Interactive comment on “A Salinity Module for SWAT to Simulate Salt Ion Fate and Transport at the Watershed Scale” by Ryan T. Bailey et al.

Received and published: 16 May 2019

Fig. 1. Figure 4

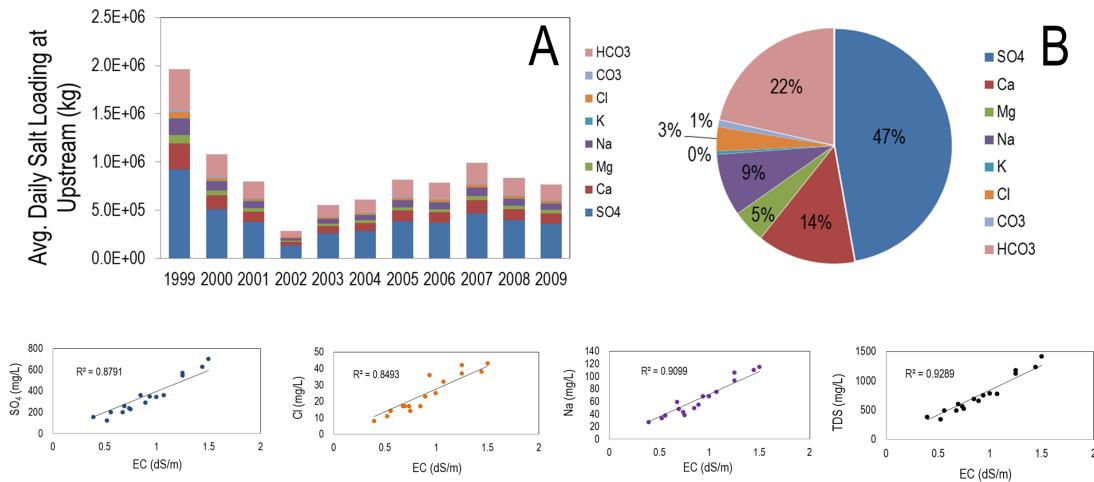
Fig. 4A: In this figure one cannot distinguish the different ions. Please modify.

Response: This figure was changed to show average daily salt ion loading, for each year (1999-2009). The values for each salt ion can now be seen more clearly.
